Stockpile Pad Paving

Merrill Industries

Merrill Industries, Inc. - Drainage Plan (Review - Response)

RE: Paving of Metals Stockpile Yard-Site Plan Review
Merrill Industries, Inc.
601 Danforth Street

DRAINAGE & GRADING PLAN
OF:
MERRILL'S MARINE TERMINAL
PORTLAND, MAINE
FOR:
MERRILL INDUSTRIES, INC.
601A DANFORTH STREET
PORTLAND, MAINE 04102

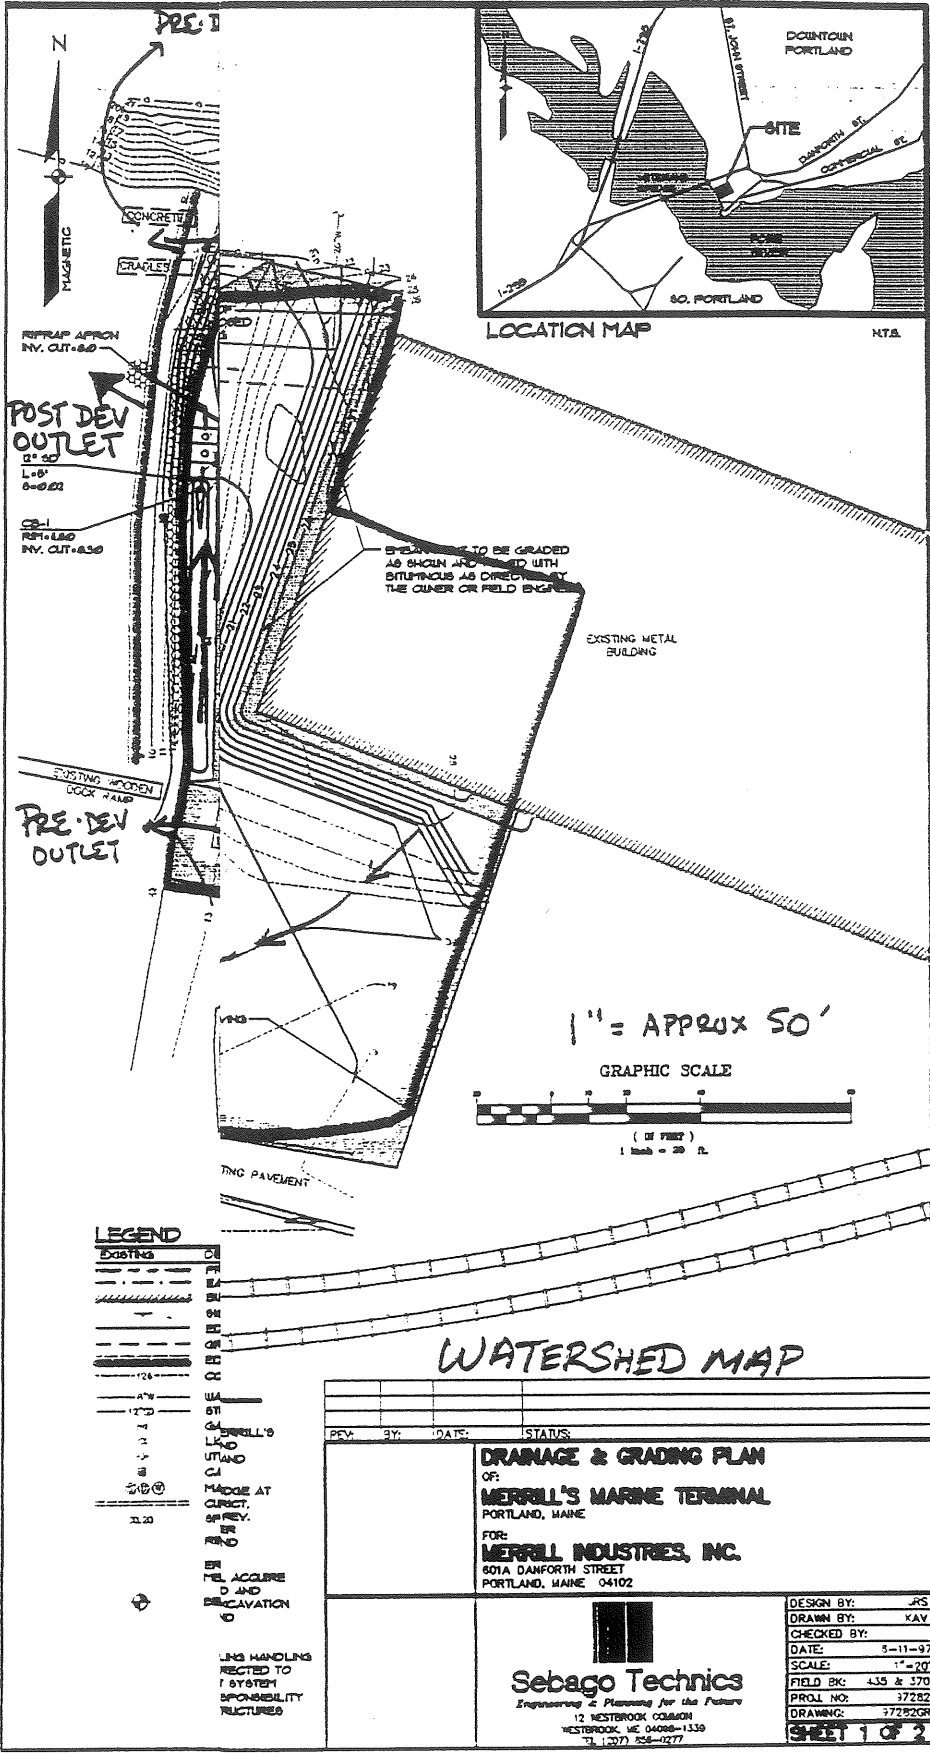
DRAINAGE & GRADING PLAN

1. applicant needs to specify the Vortech's model to be used for this development.
2. applicant should should provide a construction detail specifying thicknesses of subbase, base and pavement.
3. applicant needs to provide maintenance schedule for the treatment tank.

2. The calculation output of pond 1 does not match the proposed plan. The plan has an 18" outlet pipe Vs the 12" outlet pipe in the calcs; the peak flow out will be different. Will the revised increased peak flow be compatible with the treatment system size indicated in the report? The limit of the pond is not clear; based on my site visit, it appears that containment of runoff up to elevation 13.8 will not occur. If elevation 13.8 is intended to be the top of the existing bit curb, than containment will not occur. There is a break in the existing curb for access to the existing wooden dock ramp and the contouring of the drive to the south indicates that the "pond" is open. The pond shape should be clearly defined.

3. If the schedule of the project is to complete it this season, than recommend that the questions raised in item 2 above, be resolved now and have an asbuilt drawing submitted after the work is completed that substantiates conformance with item 1. It should be made clear to the owner that the work must conform to the analysis. Also, a final copy of the shop drawing for the stormwater treatment system should be submitted to the planning department.

Due to the fast-pace nature of this project and the closing of the paving season, we would like to finalize your review as soon as possible. To expedite both your concerns and Mr. Merrill's, we have revised the drainage and grading plan to "accurately" collect on-site runoff and direct it to the proposed paved ponding area and stormwater treatment system.

I understand your concern regarding the change of a 12" storm drain to an 18" pipe, but this change was per the recommendation of the stormwater treatment tank manufacturer. Based on their experience, the 18" pipe provides a better flow character in terms of velocity and generating an initial swirl within the grit chamber of the treatment tank. The increase of the storm drain, in fact, will not increase the flow from the site because the tank baffles and orifice outlet within the tank will actually restrict the flow rate to nearly the same as the 12" pipe.

We have attached a revised site plan correcting drainage collection to the treatment area and included a copy of the treatment tank drawing as produced by Vortechincs. We believe these revisions have addressed your concerns and provide the necessary treatment to assure water quality entering Portland Harbor and the Fore River.
